Erosion and Sediment Control Inspection Report

General Information			
Project Name	Goodwin Industry 5.0 High School	**Approximate Acreage:** 12	
Owner/Permittee	Goodwin University		
Watershed Management Permit No.:			
Site Location	2 & 3 Pent Road, East Hartford, CT		
Date of Site Visit	09/11/2025	**NPDES Permit No. (if applicable):** ILR	
Observer's Name & Title	Judy Ascano Schuler, P.E., Principal Engineer		
Enforcement Officer			
Stage of Construction	Phase II	**Photos Taken** ☑ Yes ☐ No	
Type of Site Visit: ☑ Routine ☐ Post-Storm Event ☐ Other: _____			
Weather Information			
Weather Conditions: Sunny, 75 degrees at 1:45pm			
Estimated end date of most recent ≥ 0.5" rain event: September 7, 2025			
Site Observations – Describe Location and Recommend Corrective Measures on Back Page

CONCRETE WASHOUT AREA

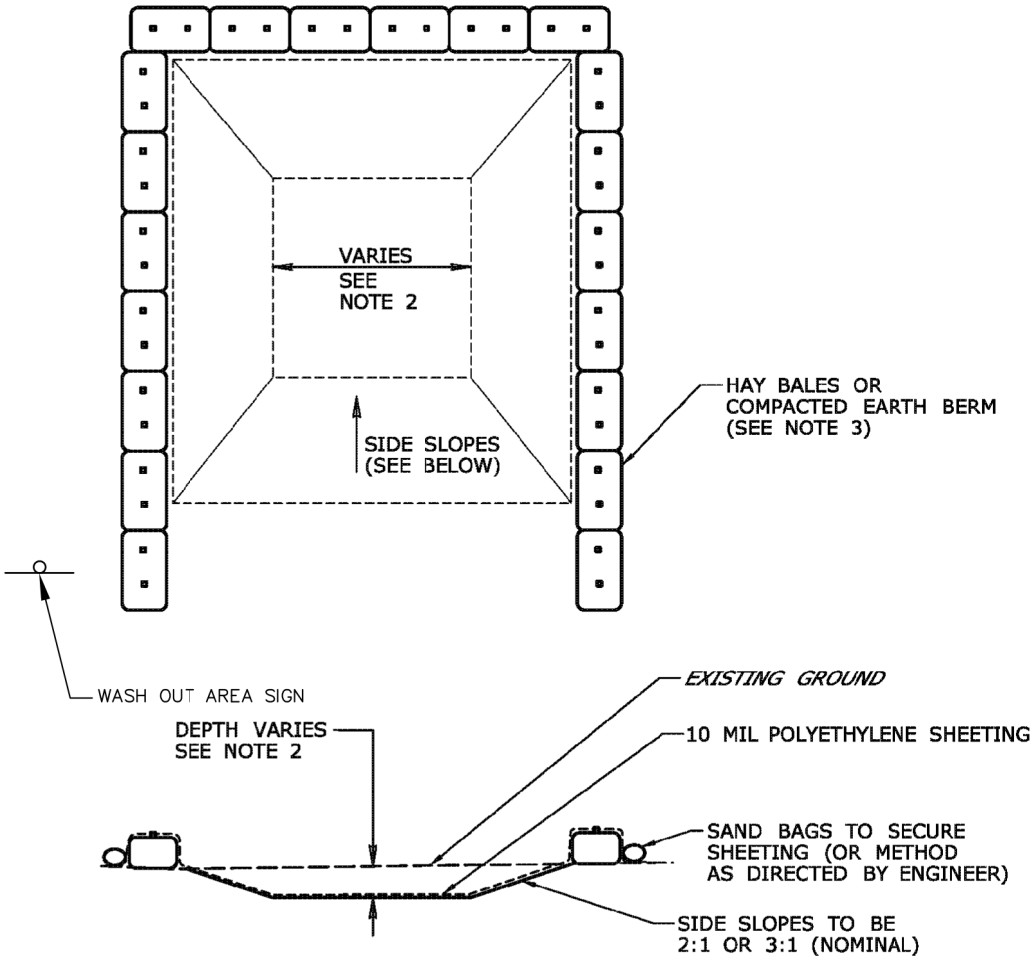
10	Are washout facilities (e.g., concrete washouts, etc.) available and maintained?	☐ Yes ☑ Action Item ☐ N/A
11	Is waste, including building materials and construction debris, collected and placed in approved receptacles?	☑ Yes ☐ Action Item ☐ N/A
12	Are non-stormwater discharges (e.g., dewatering) properly controlled?	☑ Yes ☐ Action Item ☐ N/A
13	Are vehicle and equipment fueling, cleaning, and maintenance areas free of spills, leaks, or any other potential pollutants?	☑ Yes ☐ Action Item ☐ N/A
14	Are portable toilets, material storage areas, and materials that are potential stormwater contaminants managed appropriately?	☑ Yes ☐ Action Item ☐ N/A
15	Are stabilized entrances installed and are adjacent roads clear of sediment?	☐ Yes ☑ Action Item ☐ N/A
16	Other, based on site conditions:	☐ Yes ☐ Action Item ☑ N/A

No.	Location and Recommended Corrective Measure	Completed/Initial
1	Sediment tracking observed in existing parking lot adjacent to east construction entrance.	☐
	Vehicles leaving site should travel over construction entrance pad before existing site.	☐
2	General comment to clean and maintain all catch basins to enable free draining of stormwater during	☐
	storm events. Some sediment and debris observed at several catch basins.	☐
3	Repair/replace silt fence at northwestern corner of site and along western border of site (placement of	☐
	construction materials have damaged silt fencing along the western border along the existing fence line).	☐
4	Concrete washout area observed at western end of site. Concrete washout areas shall be properly	☐
	contained and managed for sediment and erosion control. See attached detail for typical E&S measure.	☐
		☐
		☐
		☐
		☐
		☐
		☐
		☐
		☐
		☐
		☐
		☐
		☐
		☐
		☐
